Appendix PH1: Submitted AIA

Land at Coppid Hill House,
Wokingham

Arboricultural Impact Assessment

Project Details	
Client:	Abbeymill Homes
Project:	Land at Coppid Hill House, Wokingham
Report Title:	Arboricultural Impact Assessment
Project Number:	12357
File Reference:	12357_AIA.001
Date:	24/04/2025

Section A - A
Proposed access road within RPA of T16

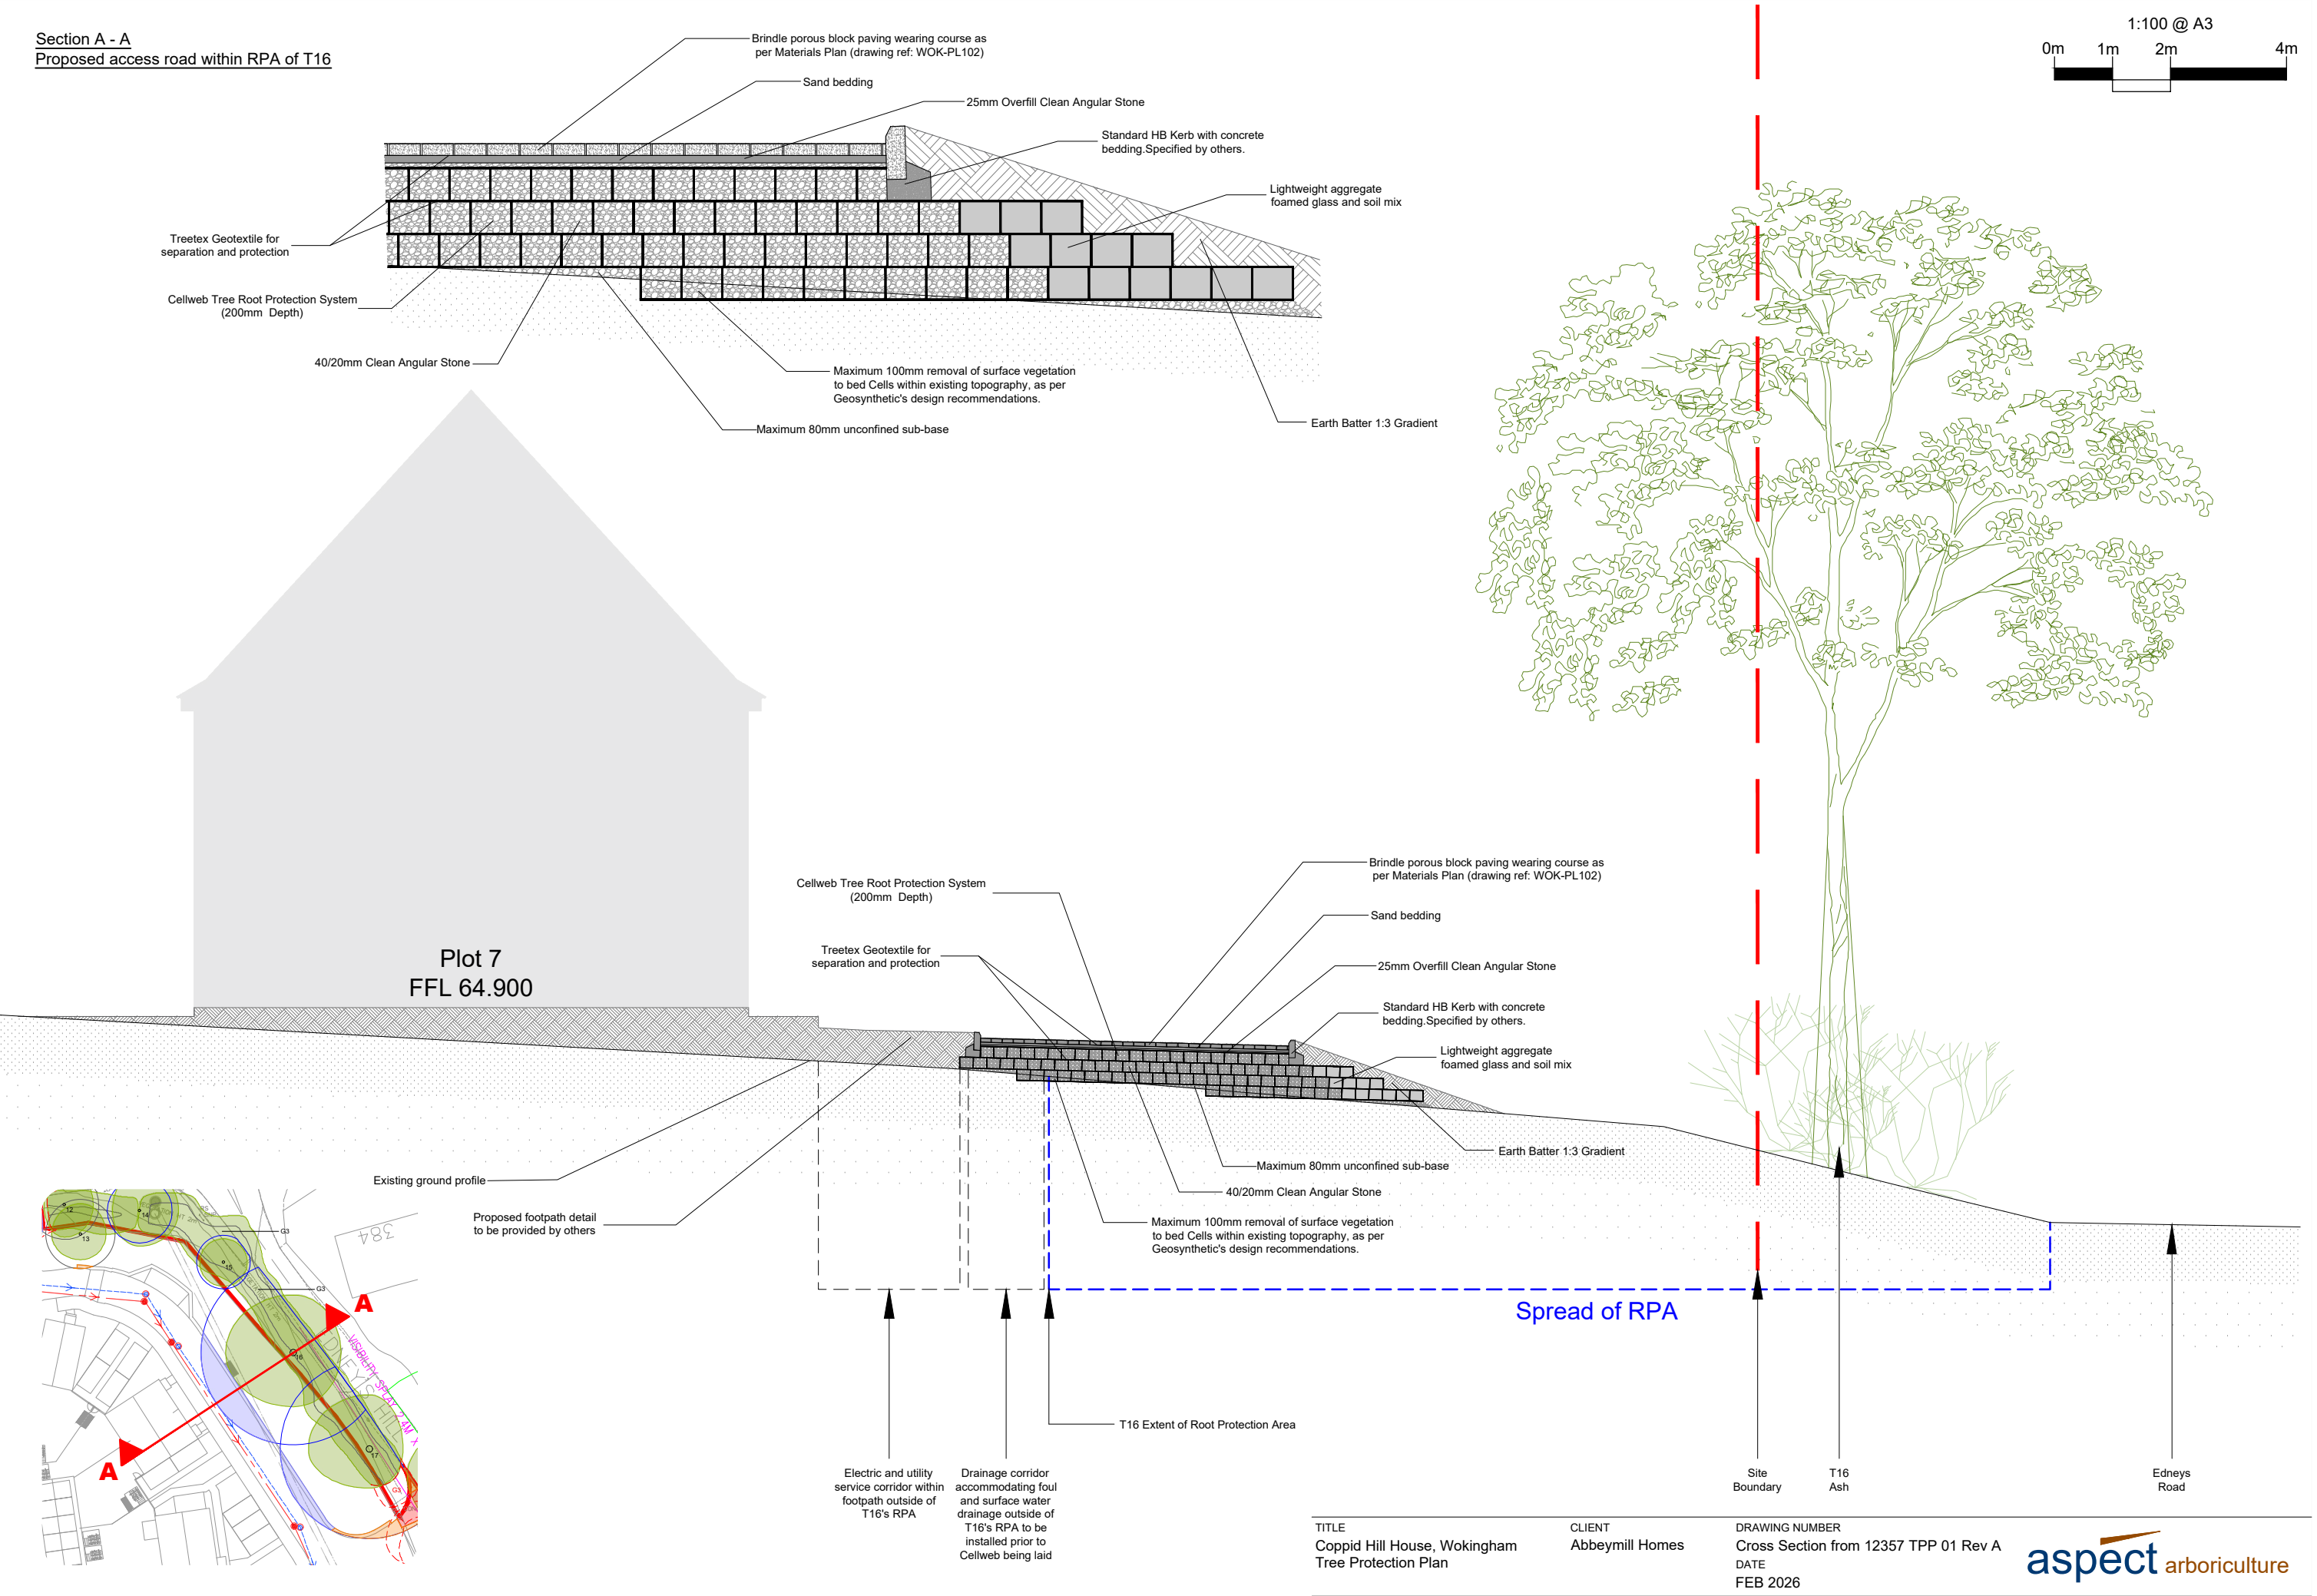
Yes—this aligns well with the recommendations I provided. The way you've applied Cellweb TRP to the section is technically sound and follows the correct approach for the scenario.

Geosynthetics are satisfied that your section uses Cellweb appropriately, and we're happy for you to proceed on this basis. If anything changes on site or if you need a quick sense-check on any detail, just let me know and I'll be glad to help.
